**Alameda County Transportation Authority
East-West Connector Project**

Final Environmental Impact Report
(SCH# 2007102078)

**Volume 2: Comments on the Draft EIR
and Responses to Comments**

April 2009

East -West Connector EIR - 2015 WithProject
Select link on wb Paseo Padre on-ramp to SR 84
AM Peak 1- Hour

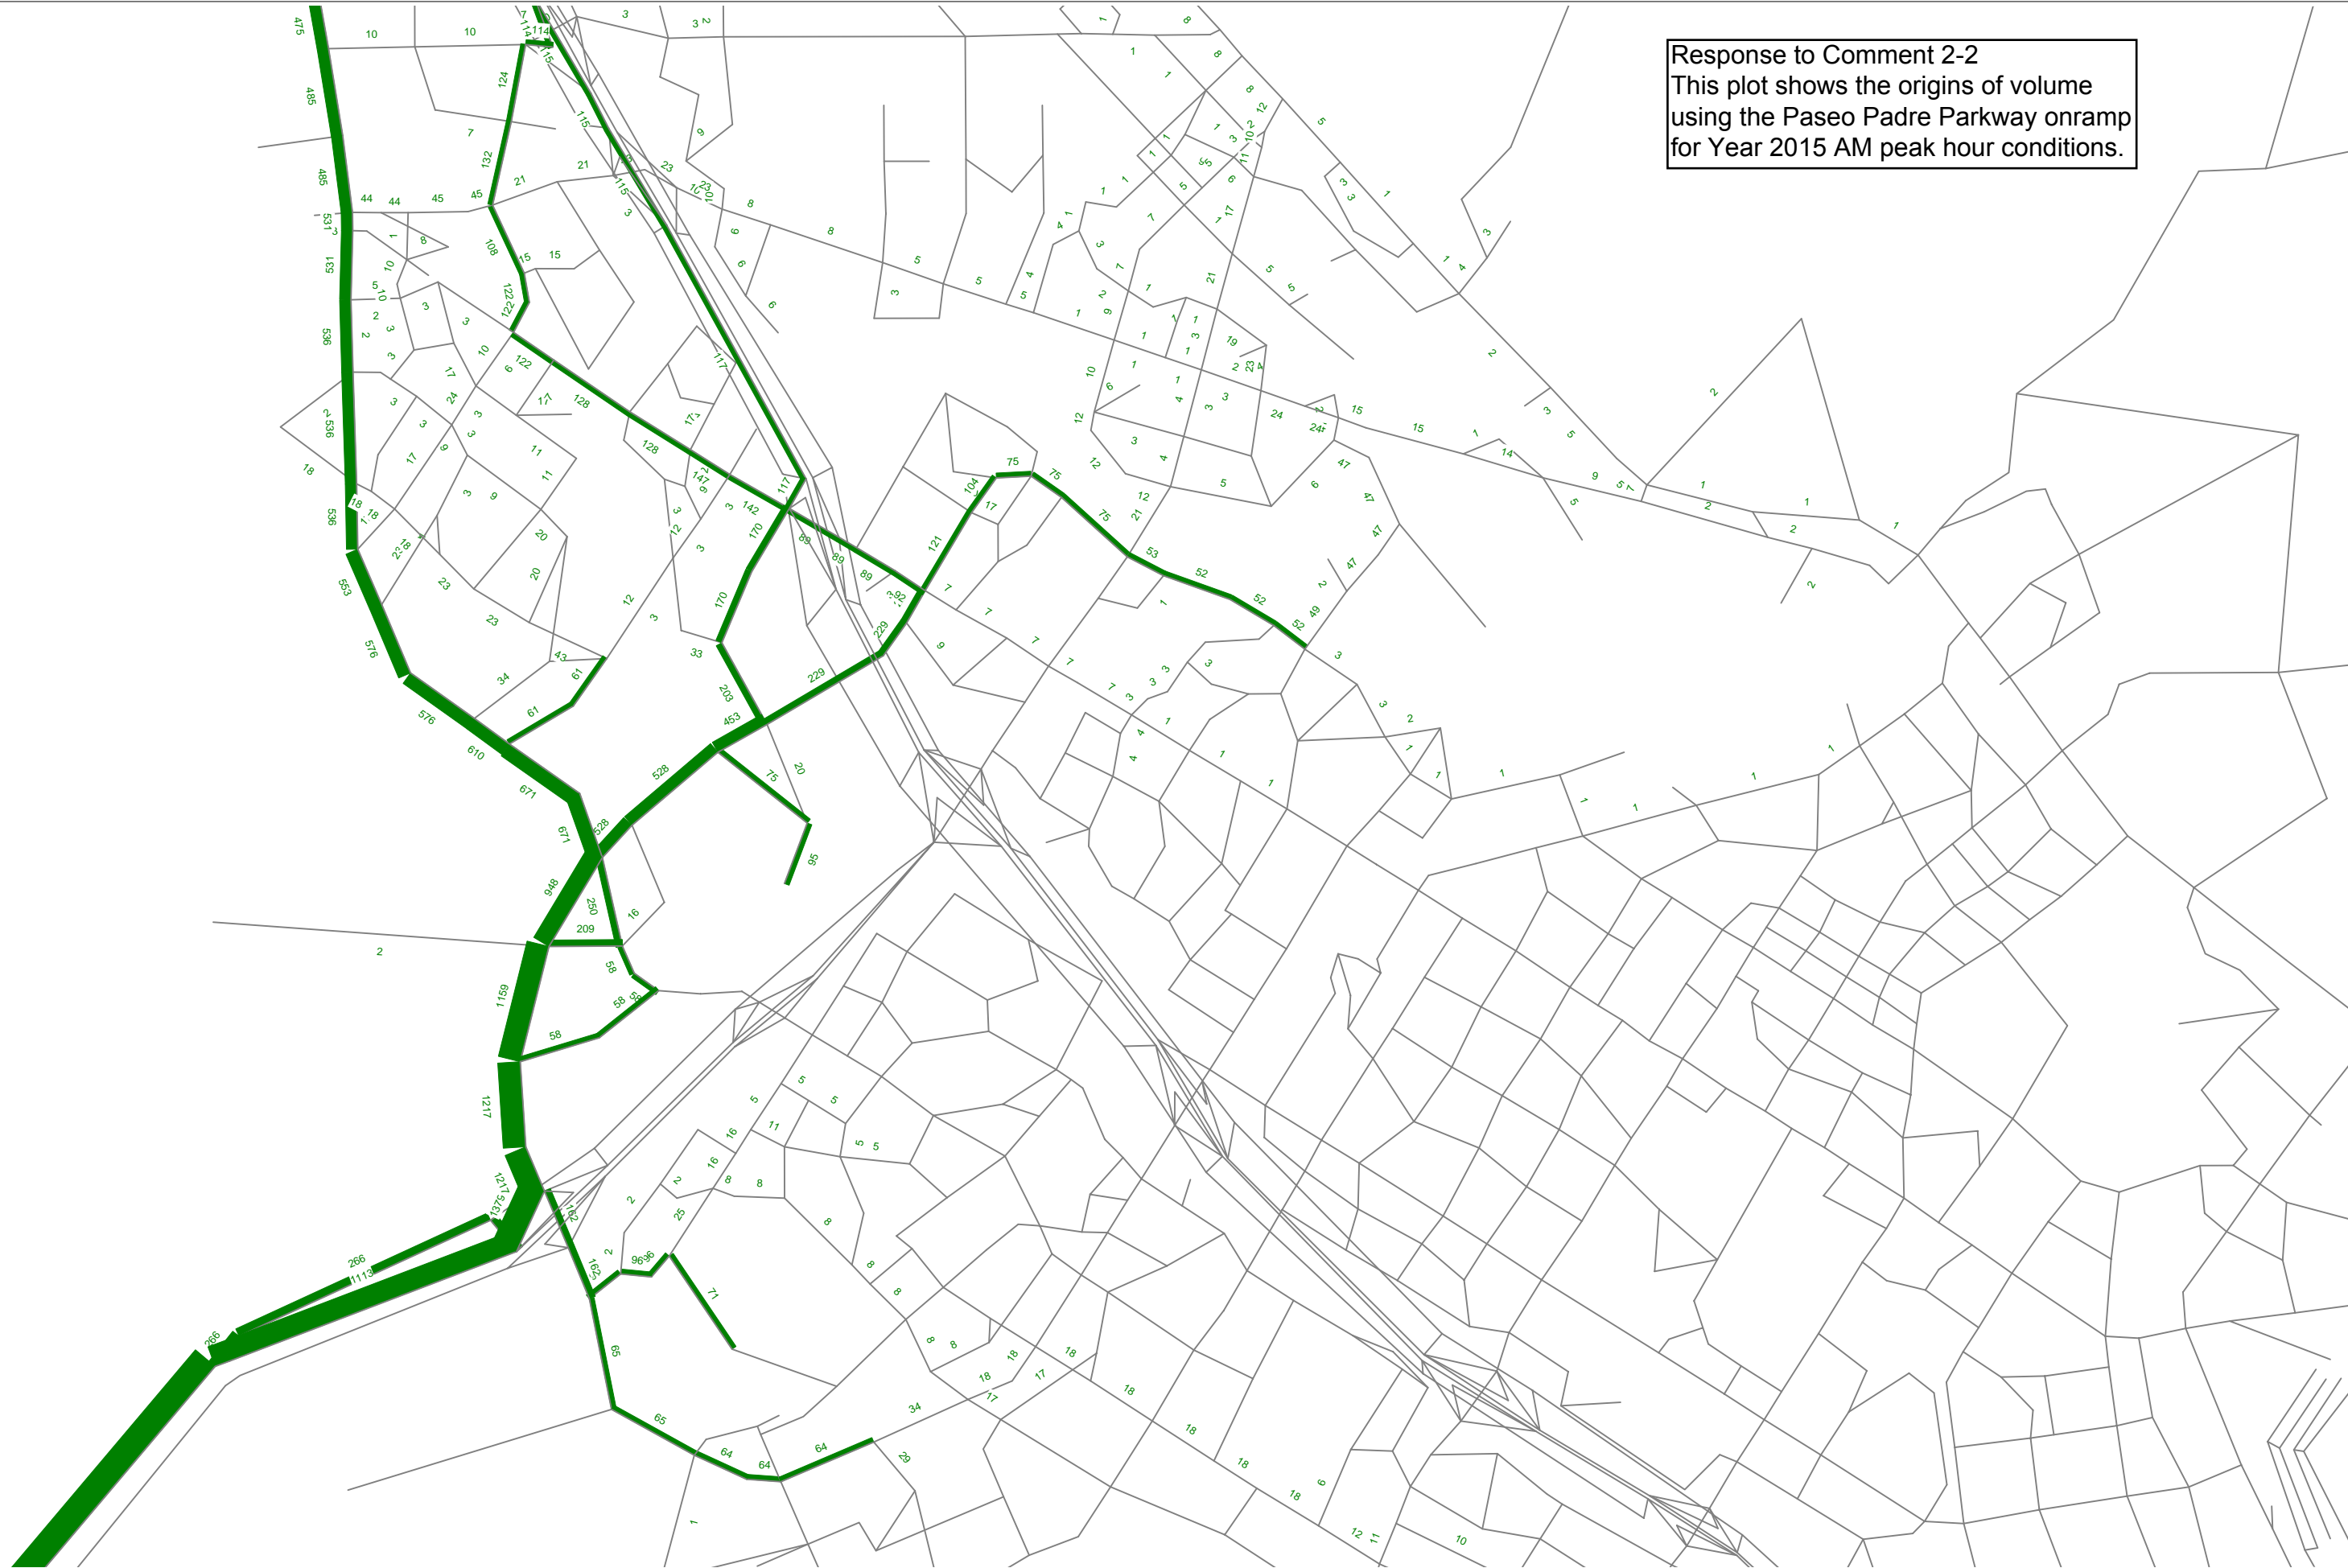
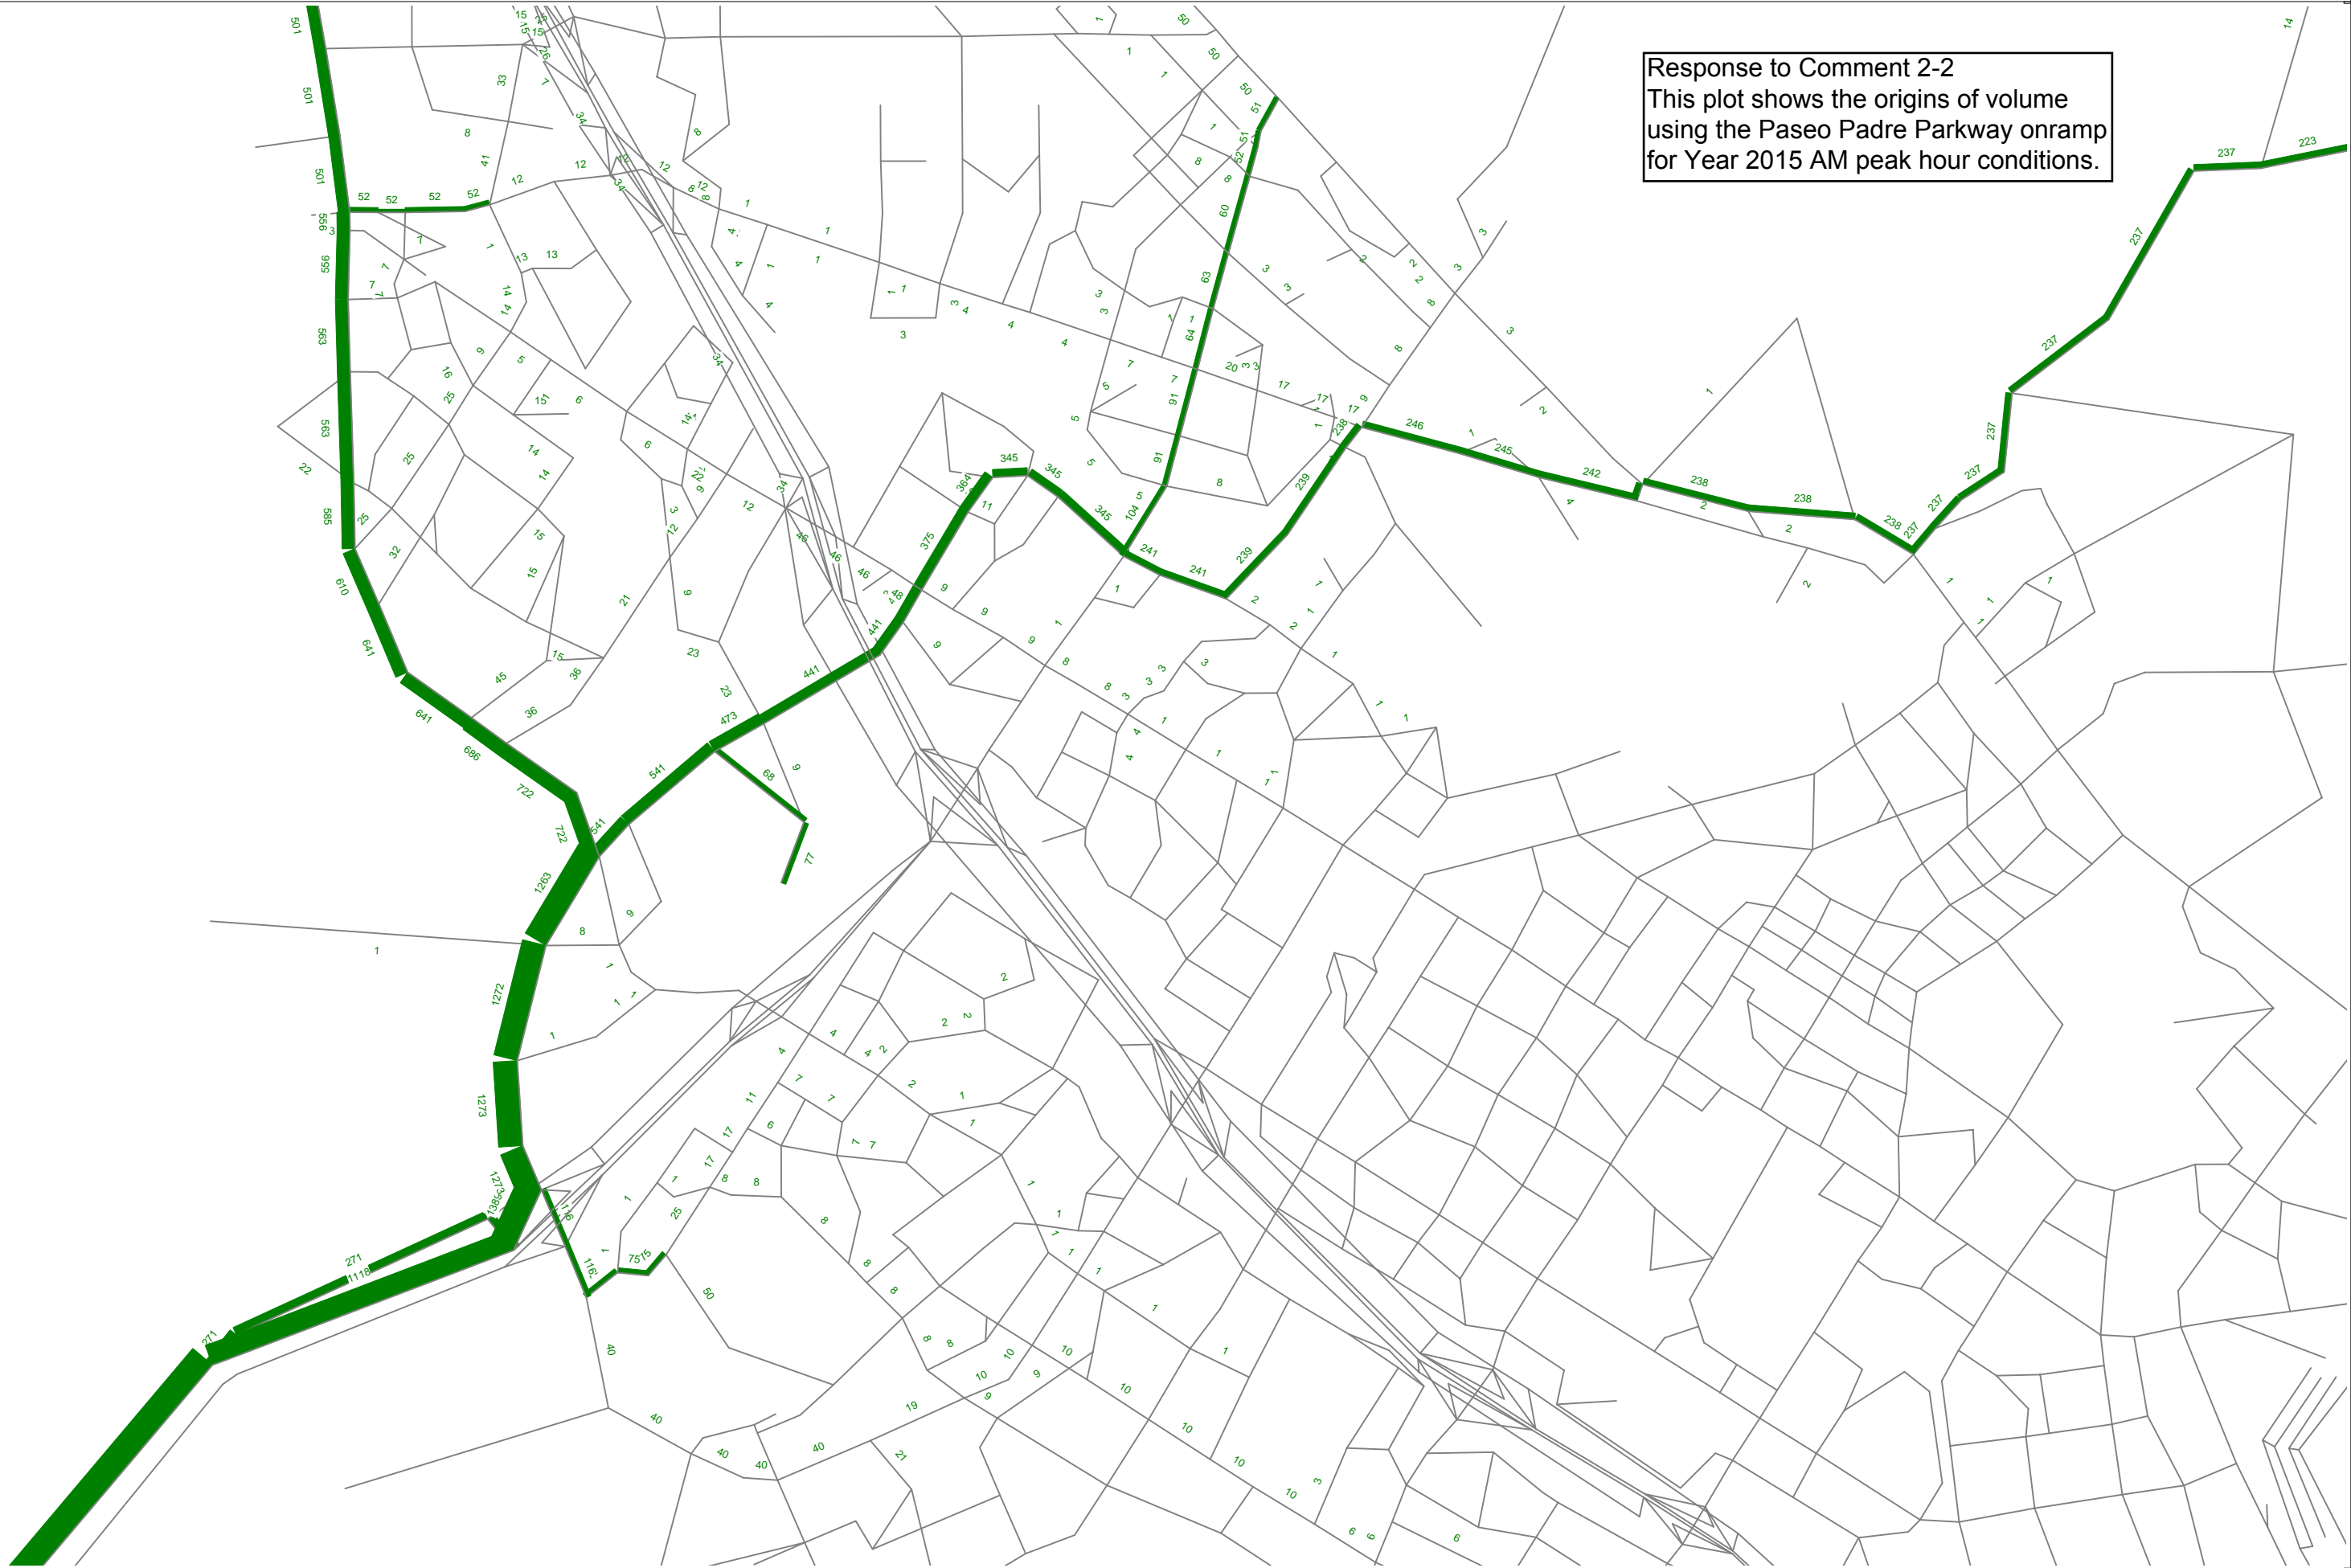
The comment states that the proposed project should result in at least an acceptable level of service (LOS) D at the State Route intersections, and that freeway on/offramp intersections should be analyzed to eliminate any queuing onto the freeway.

Plots showing the origins of volume using the Paseo Padre Parkway onramp for Year 2015 AM peak hour conditions are attached (following Response to Comment 2).

Response to Comment 2-2
This plot shows the origins of volume
using the Paseo Padre Parkway onramp
for Year 2015 AM peak hour conditions.

Response to Comment 2-2
This plot shows the origins of volume using the Paseo Padre Parkway onramp for Year 2015 AM peak hour conditions.

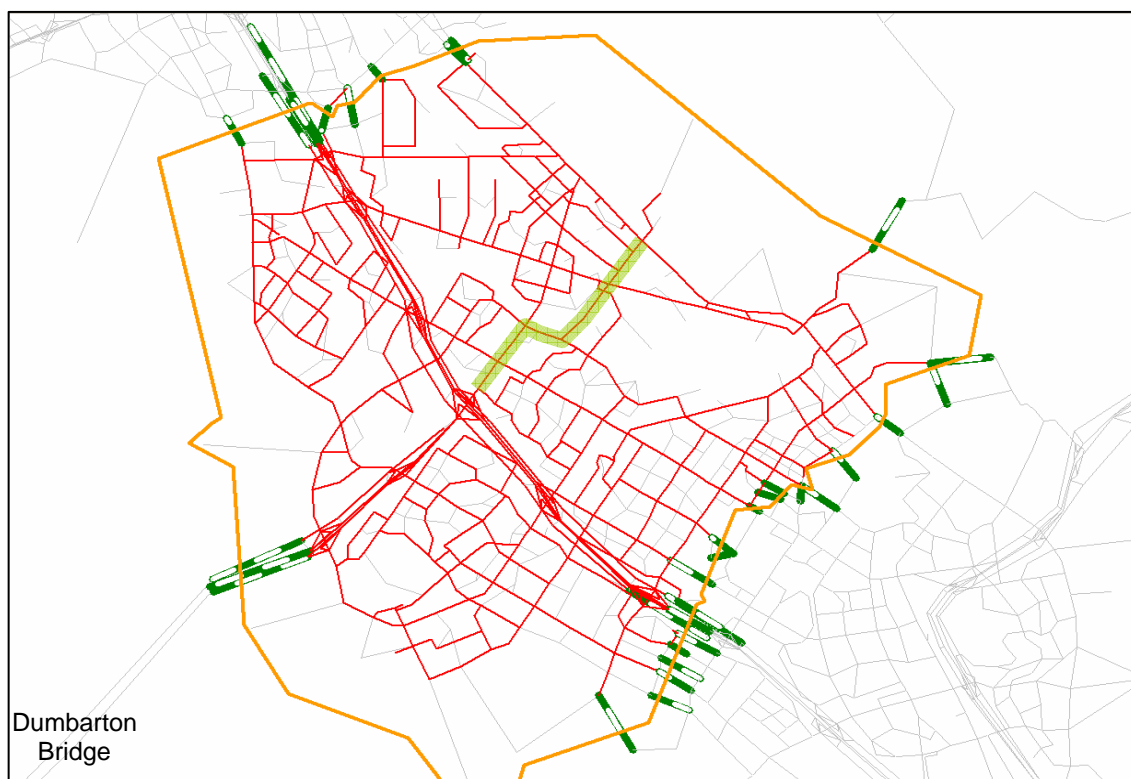
This comment seeks clarification on whether visual simulation #4 (Figure 3.1-12) is intended to show the view of the project site with or without incorporation of mitigation measure AES-5, which calls for the preclusion of tall trees from the portion of the project landscape plan between the two proposed bridges over Old Alameda Creek. The comment also suggests that this mitigation is not necessary because there are some eastern hillside views that would not be blocked by trees along the roadway, thus implying there would not be a significant impact. Lastly, the comment suggests that trees should be planted to avoid the visibility of prospective future residential development that Fremont may approve along this portion of the roadway corridor.

Visual simulation #4 (Figure 3.1-12 in Section 3.1, Aesthetics) depicts the project alignment as if Mitigation Measure AES-5 were not implemented and tall trees were planted along the roadway corridor. For clarification, a footnote has been added to the discussion of Impact AES-5 in Section 3.1 (refer to Chapter 3, Volume 1 of the Final EIR).

As illustrated in Figure 3.1-12, planting very tall trees could block views of the eastern hillsides that have been identified in Section 3.1 as important components of a scenic vista. Large-scale obstruction of these views has been identified as a significant impact due to the value of the scenic vista as perceived by recreational trail users. (Refer to the discussion for Impact AES-8: Obstruction of Scenic Vistas from Public Trails Adjacent to Old Alameda Creek in Section 3.1 of the Draft EIR.) This conclusion is based on a conservative interpretation of the general plan NR-14 policies related to maintaining views of scenic resources, and it is understood that the City considers this less-than-significant impact overall. Mitigation Measure AES-5 is not meant to preclude planting any trees along the roadway, but to preclude planting vegetation that would grow tall enough to substantially block these hillside views. Street trees may be accommodated within the project's landscape corridor. In light of this comment from the City, ACTA agrees that the 10-foot height limit incorporated into Mitigation Measure AES-5 would be too restrictive. It is ACTA's intent to provide ample landscaping in this area to—in the City of Fremont's words—"soften the urban edge," but it should also be noted that mitigation for this project should not be construed as mitigation for any future development that Fremont may undertake in proximity to the project alignment. ACTA intends to coordinate with the cities as landscape plans for the proposed project are finalized, in order to select species of trees or other vegetation types for this portion of the proposed project.

For clarification, Mitigation Measure AES-5 has been revised to specify that "extremely" tall vegetation will be avoided, to remove the 10-foot height restriction, and to indicate that ACTA will coordinate with the City of Fremont Planning Division in the preparation of the landscape plan. Refer to Section 3.1.3, Chapter 3, in Volume 1 of the Final EIR.
